# Technical Service Bulletin

## 19J1 UPDATE – 4.0 I Quality Package (NVLW)

October 31, 2013

Model(s)	Year	VIN Range	Vehicle-Specific Equipment
S6, S7, A8, and S8	2013 - 2014	See Campaign/Action screen in ElsaWeb	None

Figure 1. Coolant thermostat (2).

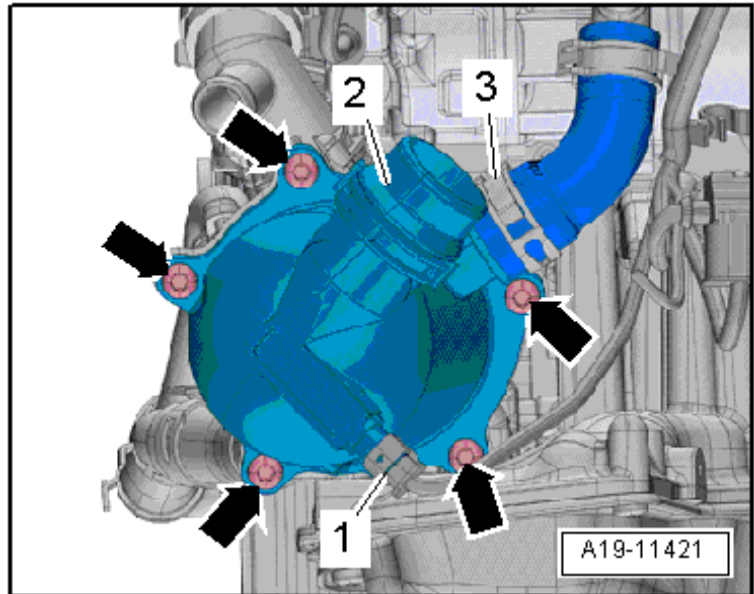
1. Replace the coolant thermostat and the quick release coupling by following the instructions in *ElsaWeb* >> *Repair Manual* >> *Engine* >> *Engine Mechanical* >> *19 Cooling System* >> *Removal and Installation* >> *Map Controlled Engine Cooling Thermostat -F265-* (Figure 1 and Figure 2).

Figure 2. Quick release coupling (1).

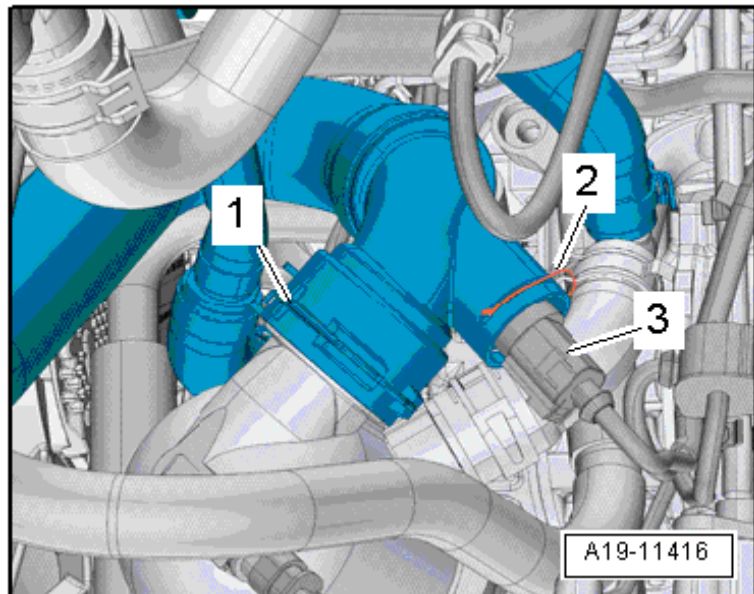
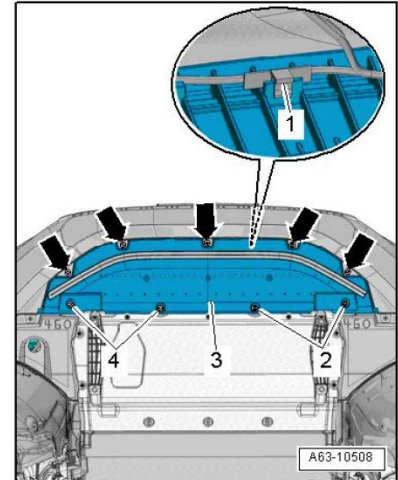
**Tip:** The quick release coupling is located directly on the coolant thermostat. It is removed together with the coolant thermostat when the coolant thermostat is replaced. However, the coolant thermostat does not have to be removed when the quick release coupling is replaced (Figure 1 and Figure 2).

**Figure 3.** Closure plate for bumper cover (3).

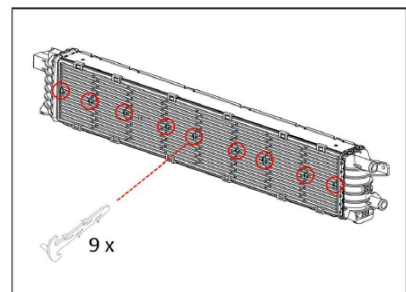
1. Remove closure plate for bumper cover (Figure 3)

*Figure 6. Location of ACF hose (A).*

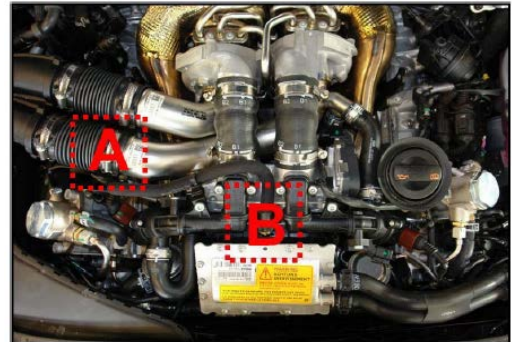
1. Replace ACF hose (Figure 6 and Figure 7). The hose clip can be re-used.

*Figure 8. Hose clip (3).*

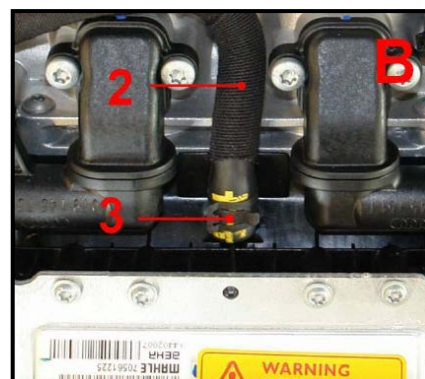
2. Replace hose clip (Figure 8).
